## City of Sugar Hill Planning Staff Report CBD Design Review 20-00703

DATE:August 12, 2020; Updated 9/10/20TO:Mayor and Council, Design Review BoardFROM:Planning DirectorSUBJECT:Central Business District (CBD) Design ReviewLidl US – NW corner Nelson Brogdon Blvd. and Sycamore Road

RE: Letter of Intent – Design Review (CBD) Highway 20 & Sycamore Road Property ID # R730647 R730648 R730649 R730650

EX-2

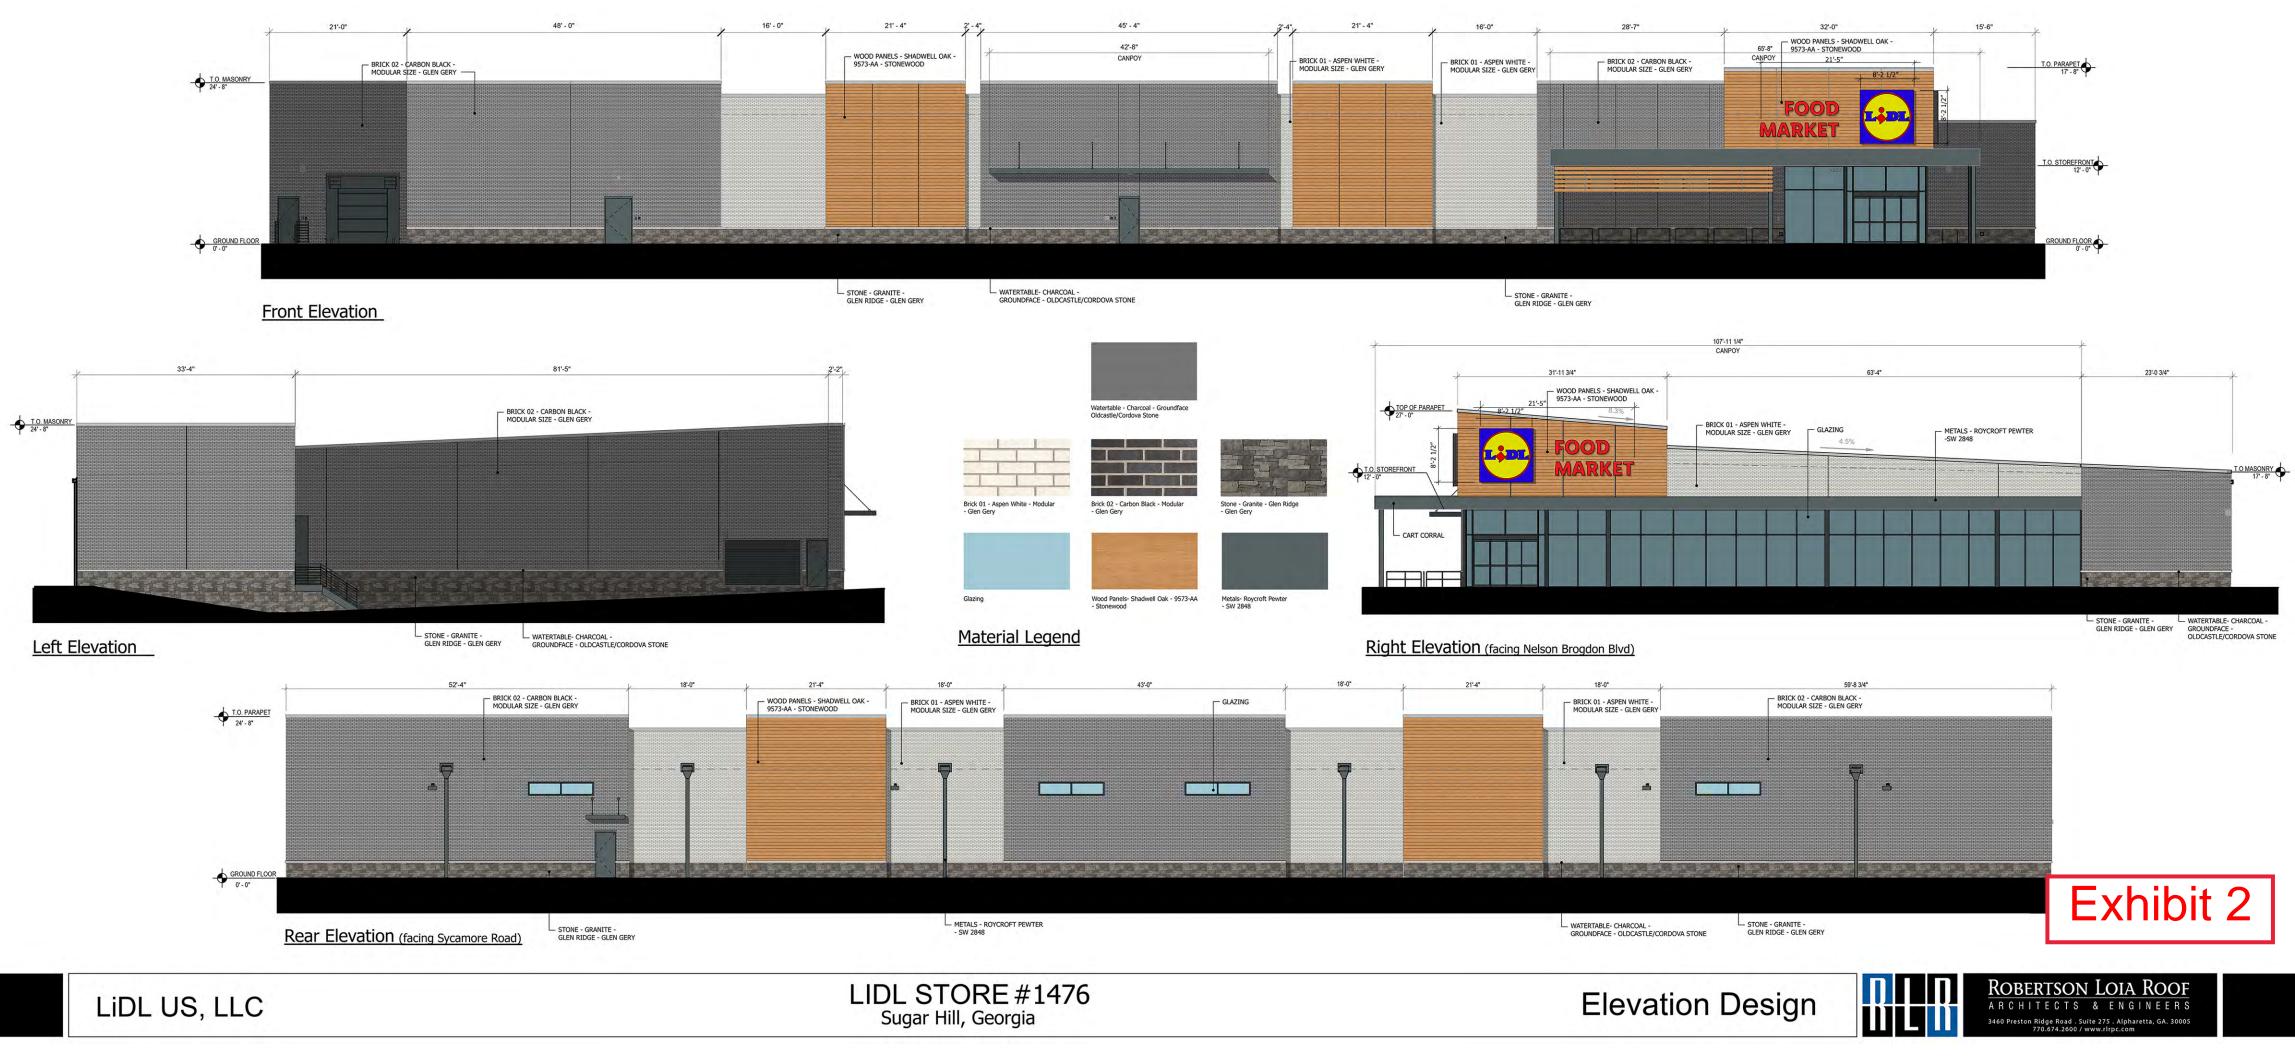
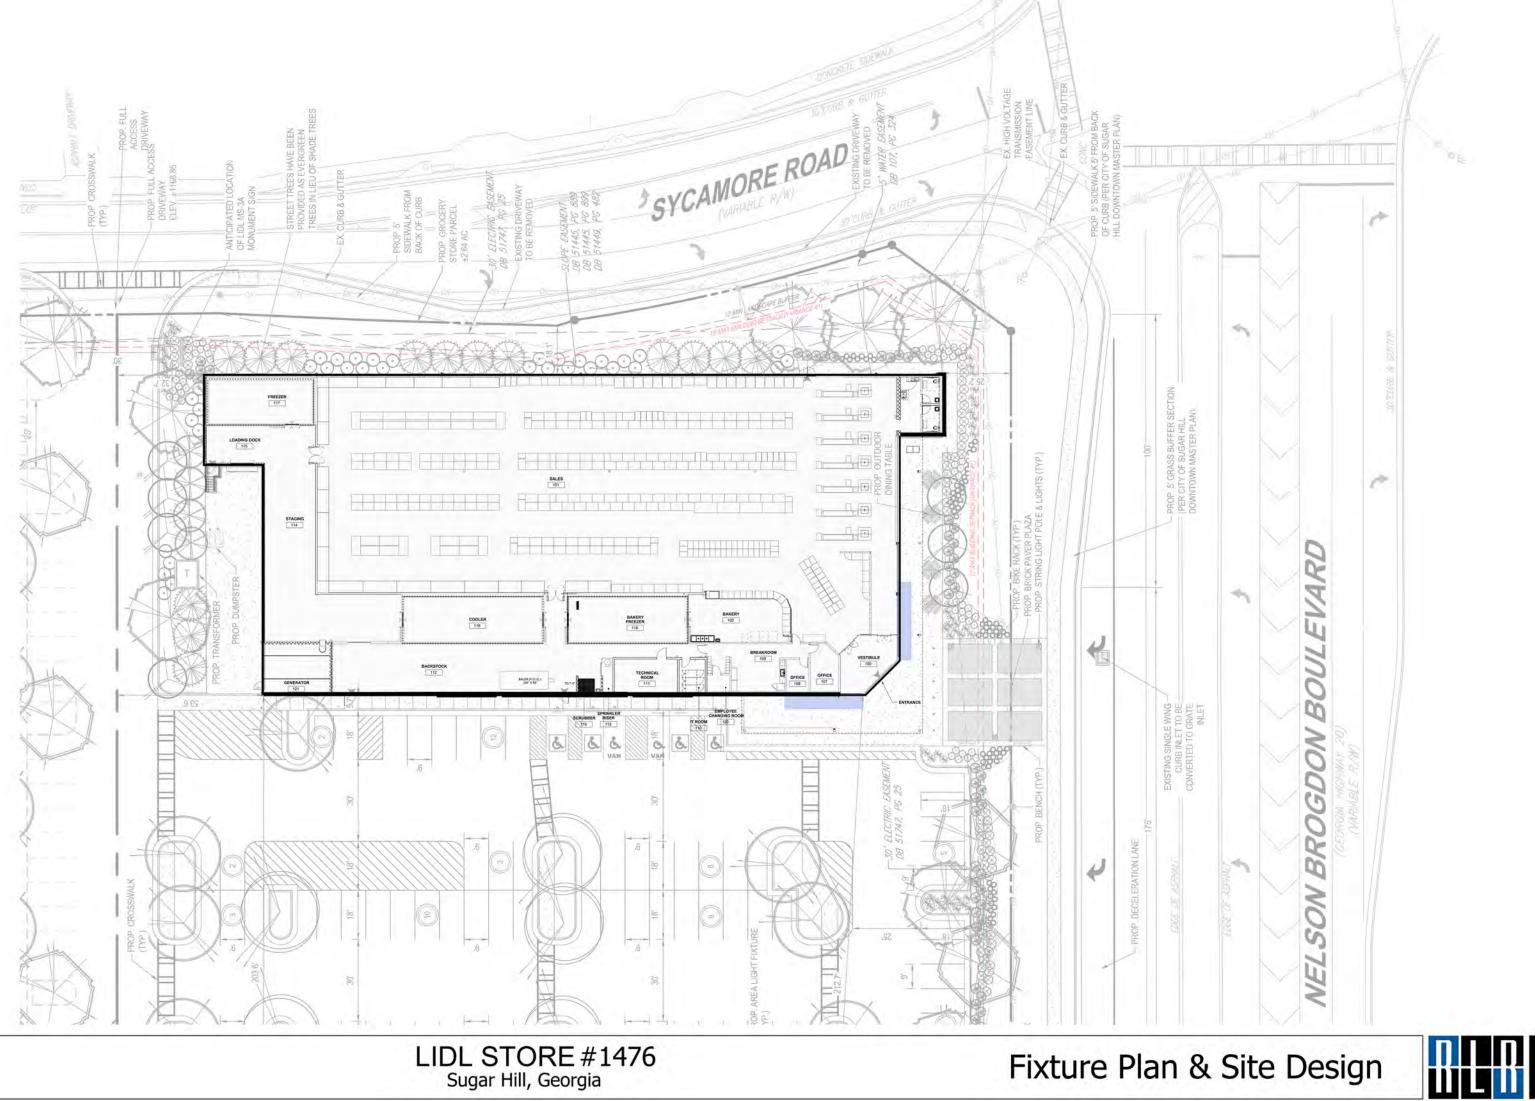
- 1. Site development and buildings shall be constructed to substantially resemble the attached Exhibits 1 2 except where modified by these conditions.

- 2. Loading dock *and* service access shall be screened from public street and sidewalk view by a privacy fence or landscaping. Screening materials shall be arranged in such a way to avoid any public safety *conflicts* for traffic, nor shall it impede any pedestrian or automotive access.

- 3. Dumpster shall be housed in an enclosure constructed of materials to match the principal building.
- 4. The same ornamental streetlights approved by GA Dept. of Transportation for Highway 20 shall be installed along the entire length of the Sycamore Road frontage.

- 5. Landscaping along Sycamore Road shall be arranged to screen the building panels in no less than 20' increments. Landscape strip shall consist of at least two staggered rows of evergreen and semi-evergreen trees and shrubs native or adapted to the area. Trees shall be 6' tall at time of planting. Plantings shall be arranged to provide an effective visual screen of at least 20' in height at maturity. Landscape strip must not contain more than 1/3 of a single species and must be shown on a landscape plan to be approved by the city manager prior to receiving any permits.

- 6. The Sycamore Rd frontage including the corner plaza at Highway 20 shall incorporate a substantial gateway art feature(s). The final design shall incorporate a water feature and must be approved by the City Manager prior to releasing permits.
